Resolution of the Long-Term Performance Issues at the Waste Isolation Pilot Plant

Matthew K. Silva,¹ Dale F. Rucker,¹ and Lokesh Chaturvedi¹

The Environmental Evaluation Group has reviewed⁽⁸⁾ the scientific effort leading to certification.

This paper summarizes the major technical issues identified by the certification process, the status of each issue, and a course of action for resolution as part of the recertification. Limited computations to examine the impact of these issues were published by EEG in 1998.⁽⁹⁾

Fig. 2. Boreholes reported to have encountered pressurized brine in the upper Castile Formation in the vicinity of WIPP.

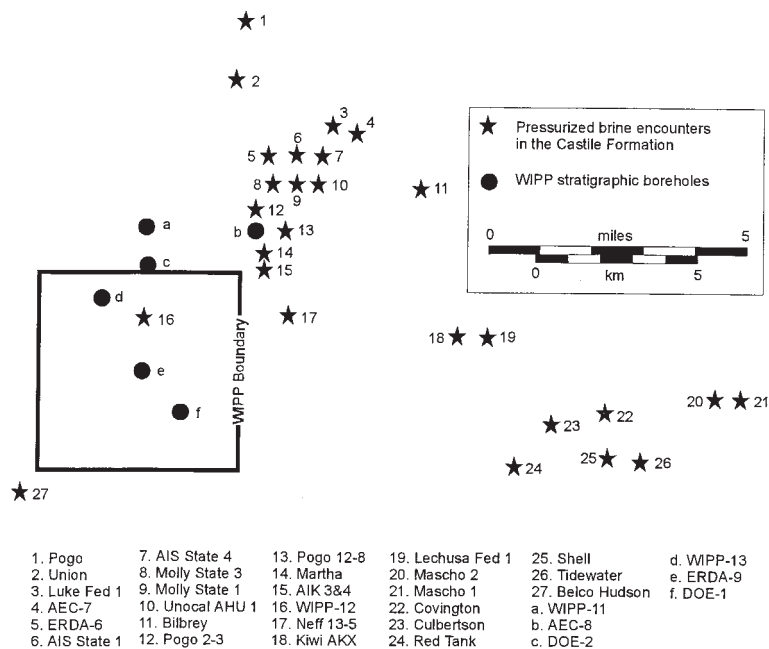
Within a few miles of the WIPP site there are at least 27 reported encounters of pressurized brine in the upper anhydrite layer of the Castile Formation (Fig. 2). Two of these encounters (ERDA-6 and WIPP-12) were in the WIPP project boreholes and the rest have been reported by oil and gas drilling companies. When borehole WIPP-12, located within the WIPP site, hit brine at a depth of 920 m, brine started flowing out of the well at a rate of 22 liters/sec and more than 8 million liters of brine were unavoidably produced during drilling, logging, and between testing.⁽¹⁷⁾ Based on an extensive series of flow tests, the brine reservoirs penetrated by the WIPP-12 and ERDA-6 boreholes were estimated to contain 2.7 billion and 100 million liters of brine, respectively. The different pressure potentials and geochemical data from the two encounters suggested a lack of communication between the ERDA-6 and WIPP-12 brine reservoirs. There was no consensus on the origin and the age of the brine reservoirs.

There are two areas of clustered brine encounters, northeast and east of the WIPP site (Fig. 2). The DOE used geostatistical modeling to ascertain the probability of pressurized brine directly below the repository. A correlation length of clustered brine encounters represents the average size of a brine reservoir in the Delaware Basin. Brine encounters are defined by reports of intersection of pressurized brine filed by the drillers to the State of New Mexico. All wells without a report of pressurized brine were considered to not have intercepted brine. The data on brine encounters during commercial drilling for

Fig. 4. Potential extent of WIPP-12 brine reservoir using WIPP-12 pressure recovery data, rock compressibility of $1 \times 10^{-10} \text{ Pa}^{-1}$, and reservoir thickness of 24 m.

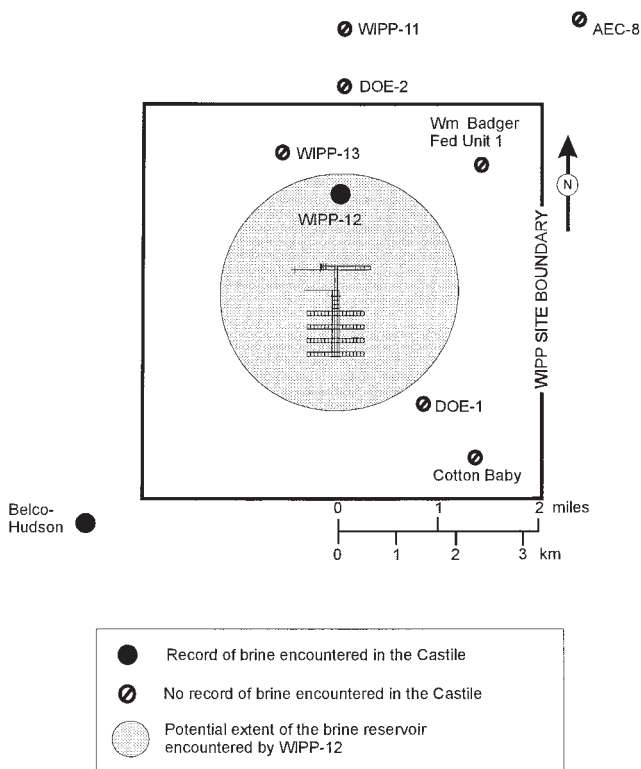
The best interpretation of the pore volume of the WIPP-12 brine reservoir is 2,700,000 m³.⁽¹⁷⁾ Assuming the maximum thickness of 24 m⁽¹⁹⁾ for the anhydrite layer containing the brine, a porosity of 0.008 (mean value in the CCA), and a pore compressibility of 10⁻¹⁰ Pa⁻¹, the radius of a circle representing the footprint of a cylinder of brine reservoir is 2 km (Fig. 4). Constrained by several boreholes in which brine was

not encountered, such a circle easily envelopes the entire repository.

Given the magnitude of the brine reservoir encountered by WIPP-12 and the results of the TDEM survey,⁽¹⁸⁾ it appears logical to assume that the reservoir intercepted by WIPP-12 extends under the WIPP repository. The 8% probability of a future borehole at the WIPP repository encountering brine in the Castile Formation, assumed in the CCA,⁽¹⁾ therefore remains unjustified.

counter by a vertical drill hole. The EEG recommended a 100% probability on the basis that the WIPP-12 brine reservoir was large enough to extend underneath the repository, a conclusion also confirmed by geophysical testing directly above the repository. The TDEM data may be interpreted to indicate the brine to be under 60% of the repository. The EPA agreed that 8% was not representative and decided that the probability should be sampled from a range of 1% to 60%. There is no technical basis for the 1% value nor does it make sense to use the probability of a probability. A fixed value of 60% should be used in recertification calculations.

Fig. 5. Tensile failed volume from GASOUT predictions for various waste strengths and waste permeabilities.

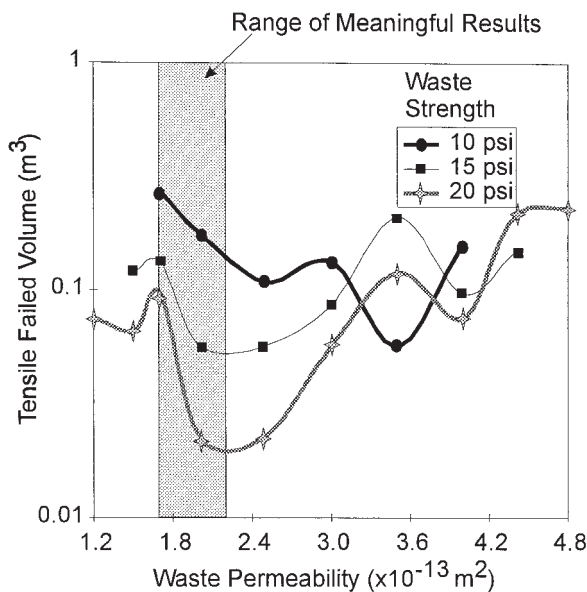
it is unknown which model’s prediction is closer to reality. Testing of the new model^(8,9) revealed serious instability problems outside a narrow range of waste permeabilities as shown in Fig. 5. For the waste strengths investigated there can be no confidence in waste permeabilities outside the narrow range of 1.7 to $2.0 \times 10^{-13} \text{ m}^2$.

The EPA maintains that the code behaves quite reasonably under expected repository conditions. Assuming “expected conditions” is suspect given the uncertainty that arises from the geologic and hydro-geologic response of the repository system, along with the gas generation from the degrading waste. The fundamental philosophy behind the PA is to sample the input parameters from an expected range. To state that one set of conditions, for which the model is applicable, correctly captures all uncertainty inherent in long-term modeling underestimates the importance of accommodating such uncertainty. A new approach is needed to develop a coherent and straightforward model to address the important issue of spall supported by a suite of appropriately designed experiments by which to determine waste strength.

As a part of the recertification effort by DOE, work is in progress to capture adequately the physics of spall in a new model. The new model will incorporate a modified wellbore hydraulics model with mixing equations for solids and fluids, a drillbit damage
